GEOCRES No:
31F-122

**ADDENDUM REPORT
ON**

**TEMPORARY ACCESS ROAD
MISSISSIPPI RIVER WETLANDS
HIGHWAY 417
W.P. 451-90-03/04
ARNPRIOR, ONTARIO**

December 1999

PROFILE
STATION 18+100 TO 18+400
(WESTBOUND STATIONS)

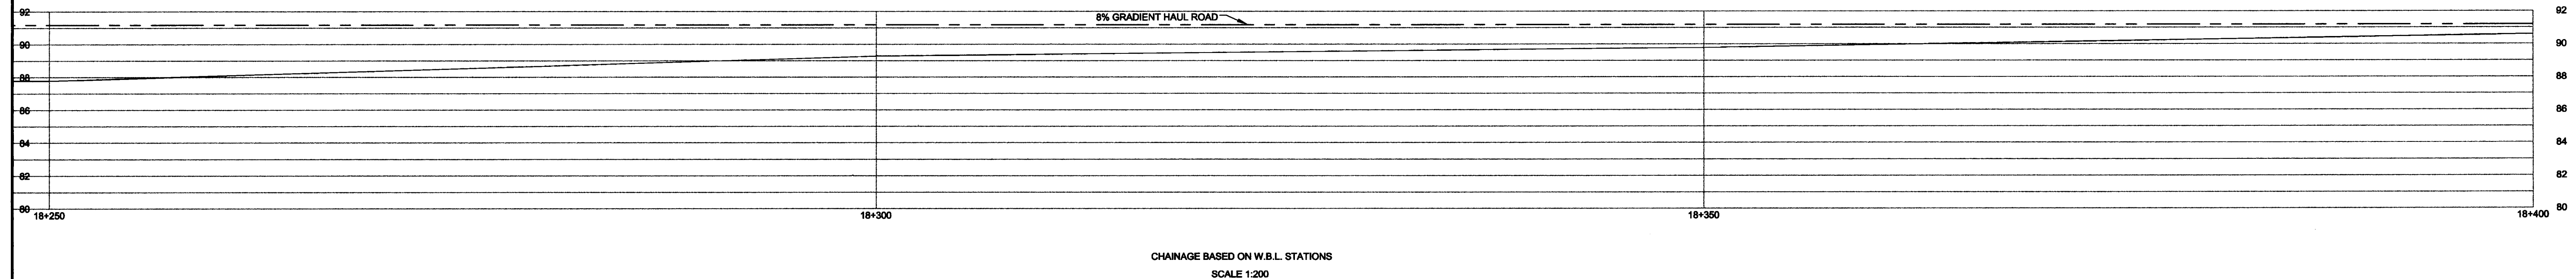
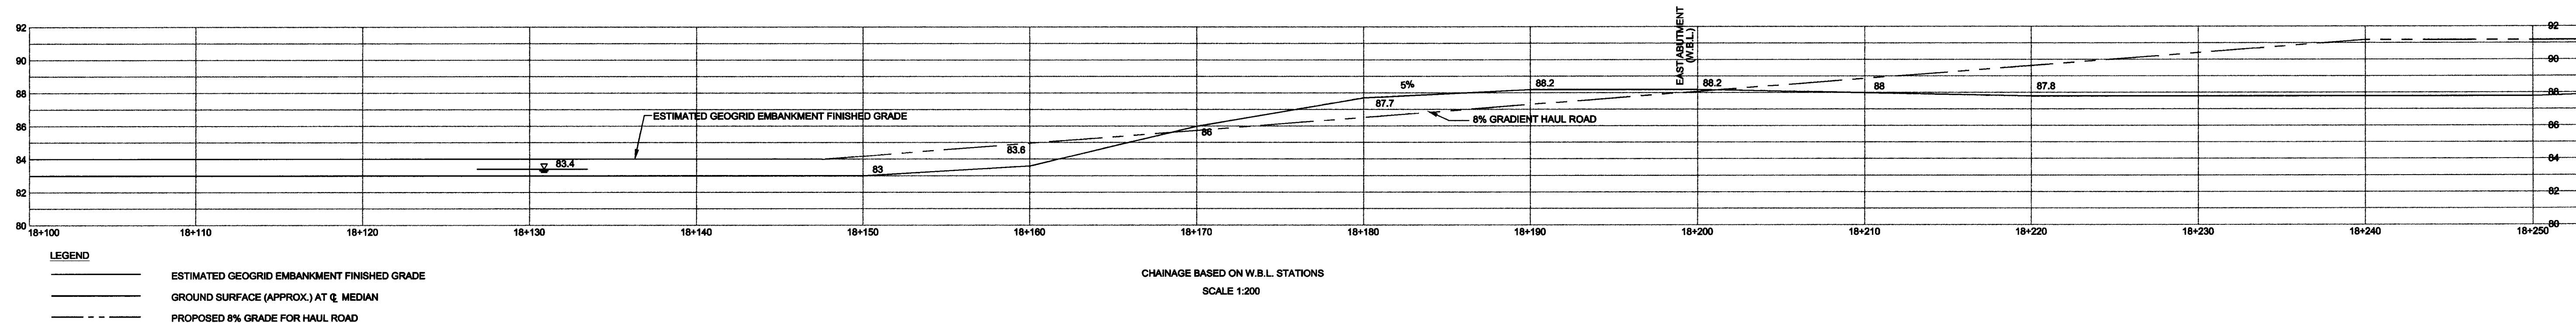
For the proposed 8% gradient for the 8 m wide haul road, fills up to 1.5 m high in the median are required as shown on Figure 1. Some adjustments with regard to fill heights will be necessary during the final design / construction period to facilitate any overlap between the geogrid

To develop an 8% gradient from Station 18+170 WBL to Station 18+200 WBL cuts up to 1.1 m will be required as shown on Figure 1. Thurber boreholes (#95-6 #95-7, #95-13, #95-14, #99-4 and #99-5) reveal the presence of a very stiff desiccated silty clay crust in the order of 3.0 m to 5.0 m in thickness with undrained shear strength in excess of 100 kPa. Since highway embankments are not required in this area, the 8.0 m wide haul road can be constructed in cuts 1 to 2 m in height to the grades shown on Figure 1 with 1.5H:1V or flatter side slopes without any stability problems. During the construction of the haul road, if necessary, biaxial geogrid and geotextile may be used to prevent rutting of the road surface.

CROSS SECTIONS AT
STATION 18+200 AND 18+210
(WESTBOUND STATIONS)

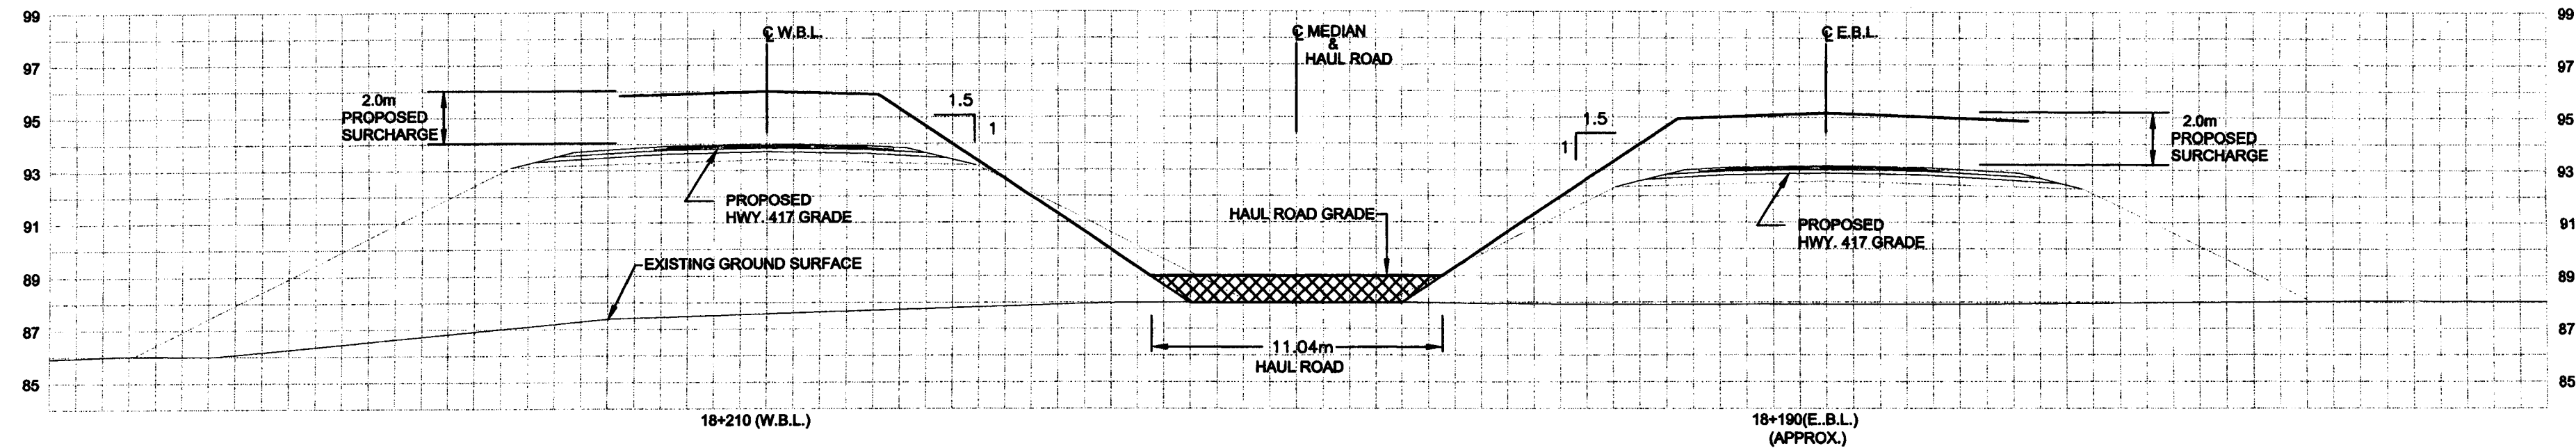
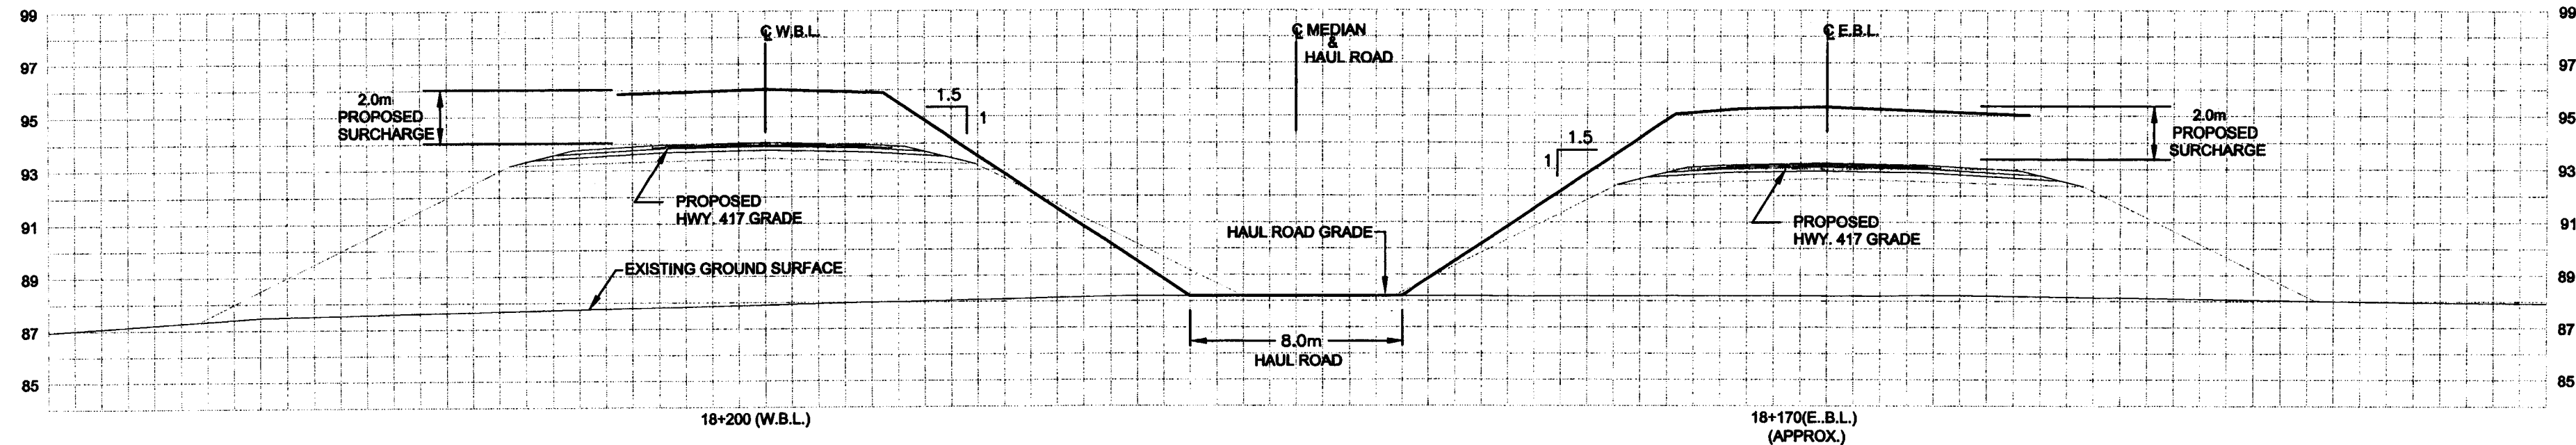
If the access road is to be at original ground surface at and behind the abutments, it will be necessary to steepen the embankment side slopes to 1.5 horizontal to 1.0 vertical (refer to Figures 2, 3 and 4).

PLAN OF PROPOSED HAUL ROAD (FILL IN MEDIAN OPTION)

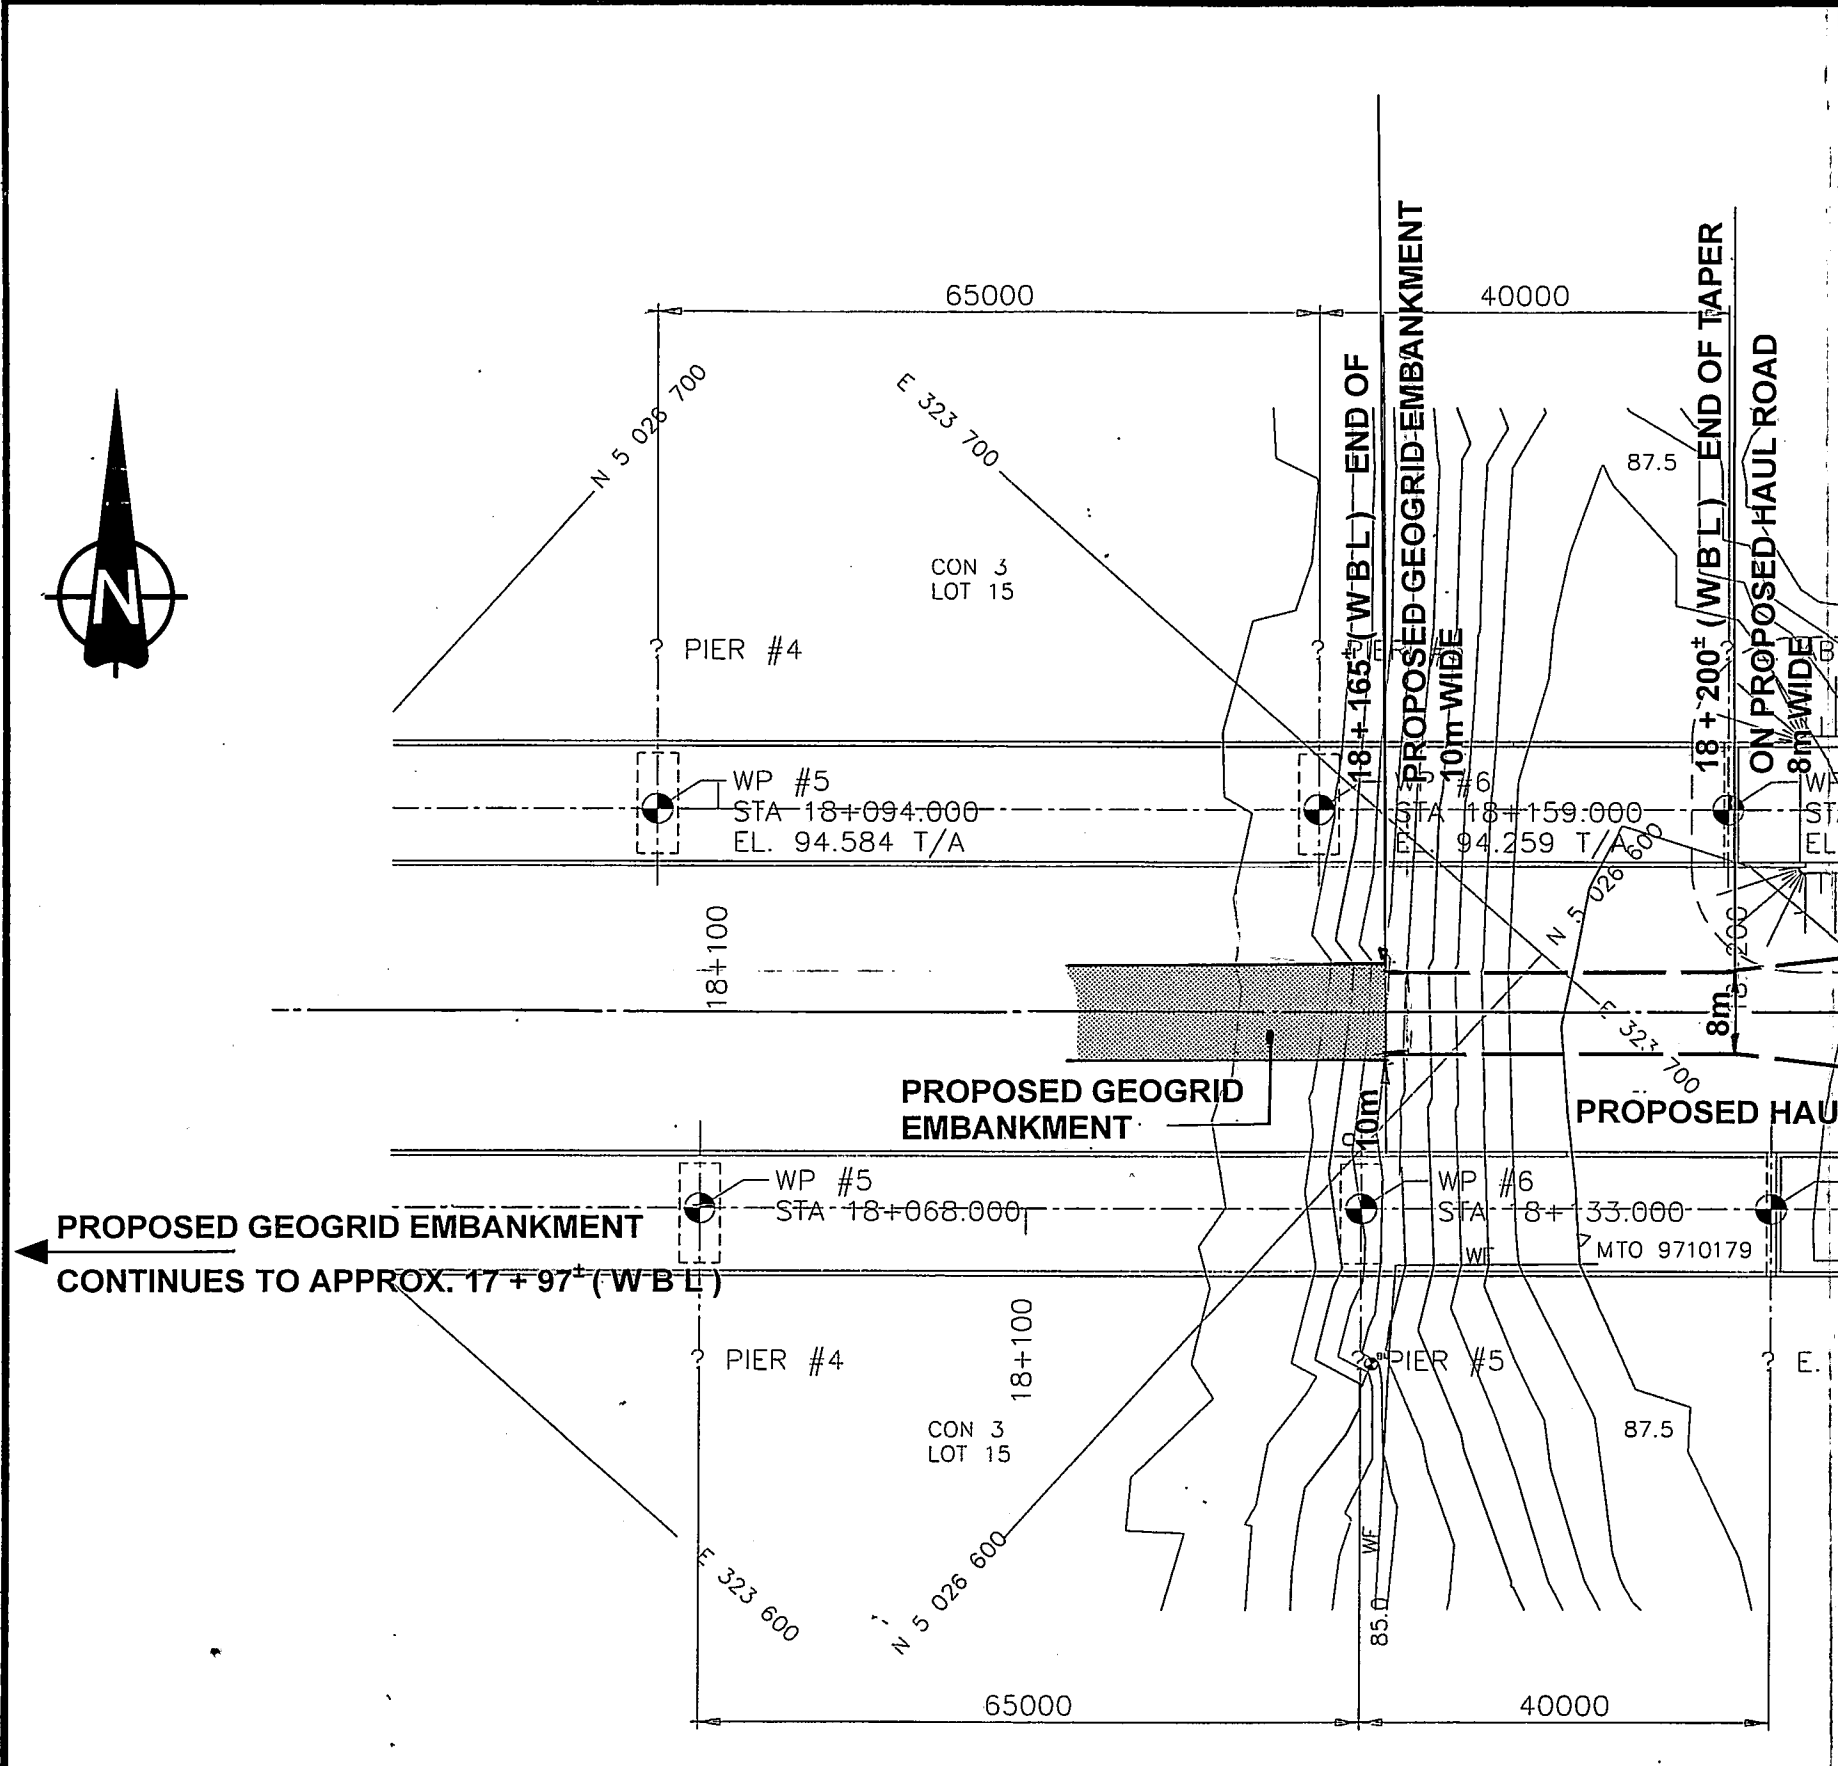
embankment and the haul road fill construction between approximate Station 18+150 and Station 18+160. It would not be possible to determine the precise easterly limits of the geogrid embankment until the time of construction by the contractor. The conditions easterly beyond Station 18+150 (WBL) are somewhat favourable and the proposed 1.5 m geogrid embankment may not settle to the extent elsewhere and possibly maintain at Elevation 84.3 m. In such a case the 8% gradient could be terminated at approximate Station 18+154 (WBL) which will smoothly blend with the geogrid embankments. A plan showing the haul road from Station 18+154 to about station 18+250 WBL is shown on Figure 5.

MTO HIGHWAY 417	
ARNPRIOR,	ONTARIO
GEOGRID LAYOUT	Sheet Number 5A of 5

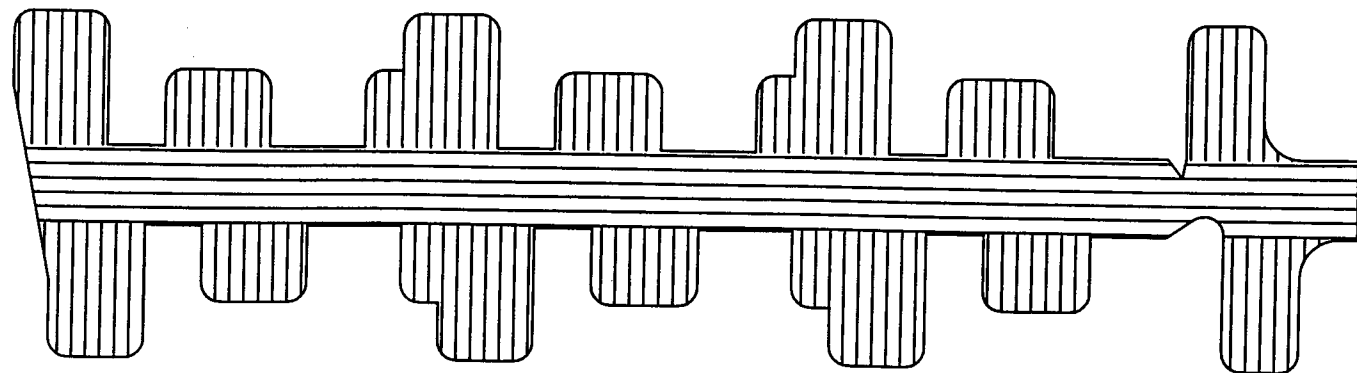
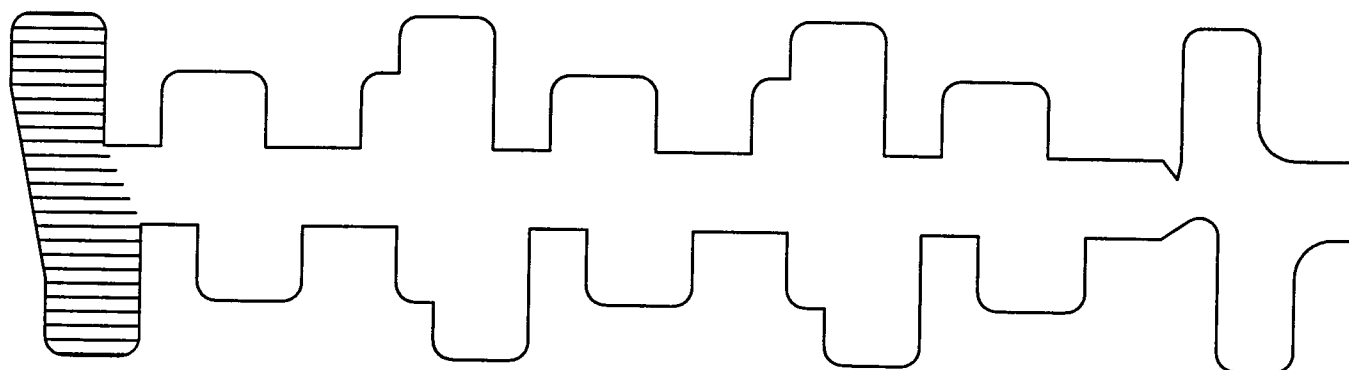
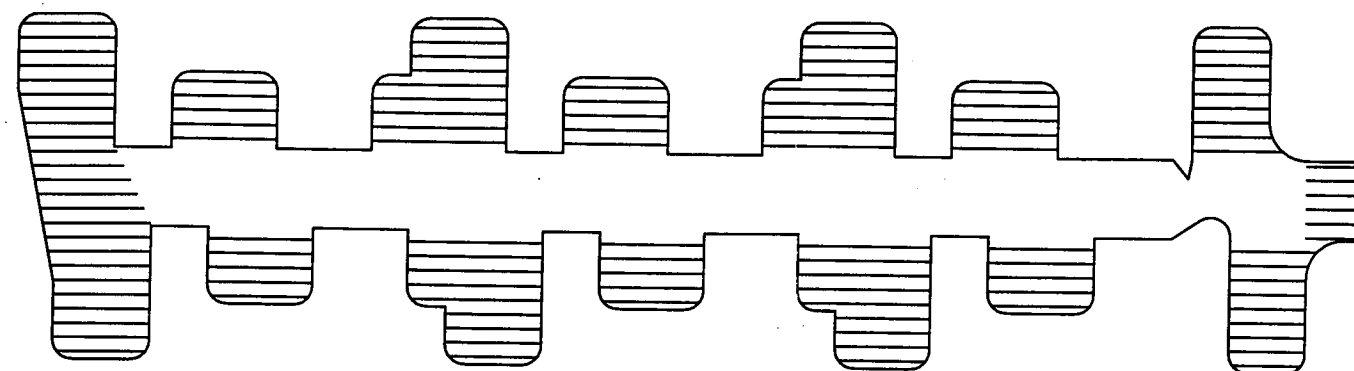
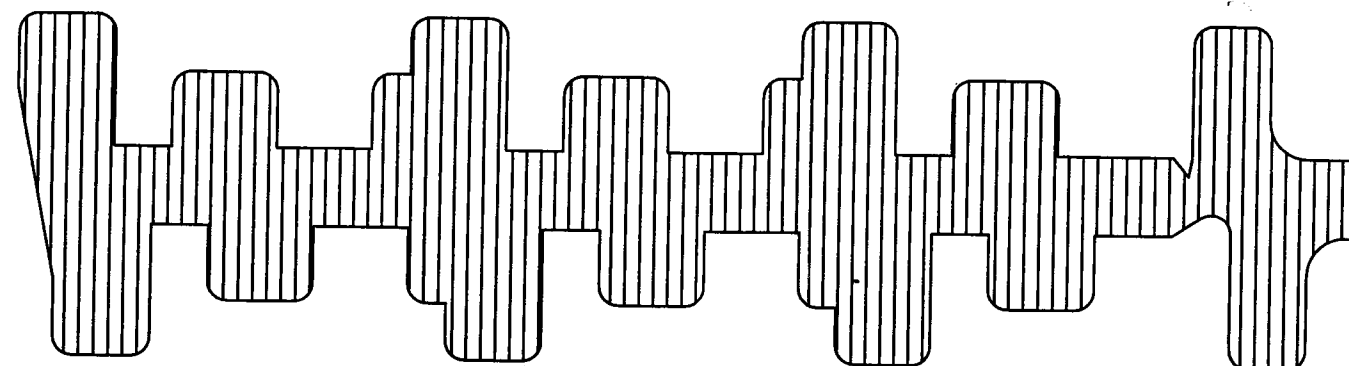
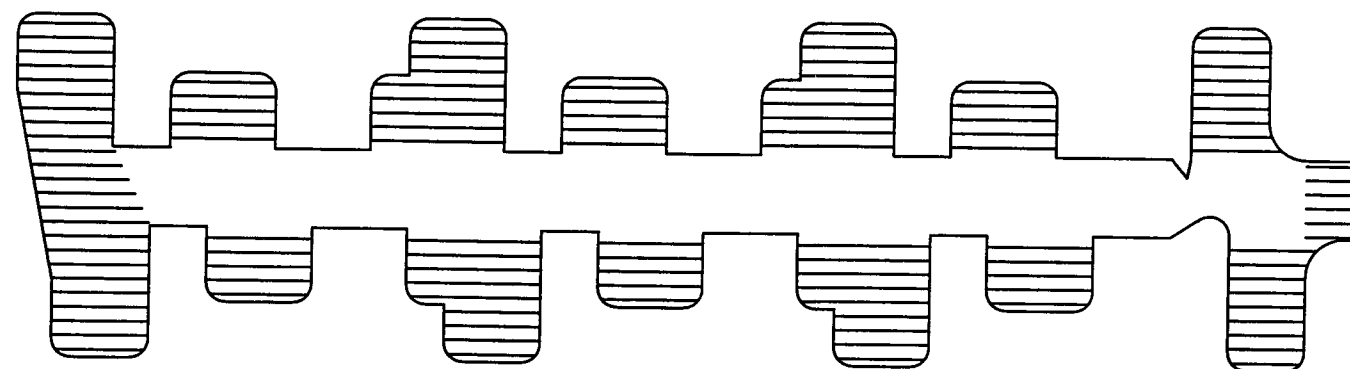
experience. This pipe has the strength and flexibility to accommodate the anticipated deformations. The pipe is available with an inside 0.460 m smooth wall diameter. Care should be exercised to prevent any damage to the pipe by providing adequate cover to the pipe during the construction of the embankment. Installation details are given on the construction notes of Sheet #2 of #5 Tensar drawings. Details are also shown on typical cross-sections (Drawing #3 of 5) and the locations on geogrid layout (Drawing #5 of 5) which are included in the appendix of this report. The 0.5 m diameter pipe could be installed at three different locations to provide passage for the fish. If 0.5 m diameter pipes are not adequate, larger diameter pipes could be considered but not larger than 0.75 m due to the vertical space restrictions between the geogrids. We also investigated a corrugated High-Density Polyethylene smooth wall pipe with outside diameter of 0.735 m with inside diameter of 0.611 m. However with the 0.735 m diameter pipe there may not be adequate cover at certain stages of the embankment construction. In such case additional granular cover would be necessary to prevent damage to the pipe from the equipment traffic. The details are shown on typical cross-sections (Tensar Drawing No. #3A of 5). If crane traffic warrants further precautions to ensure the integrity of the pipe, timber mats can be used in the pipe area. If larger diameter 0.735 m pipes are necessary, these could be placed at only two locations instead of three locations for 0.544 m diameter pipes. The locations are shown on the geogrid layout (Tensar Drawing #5A of 5).
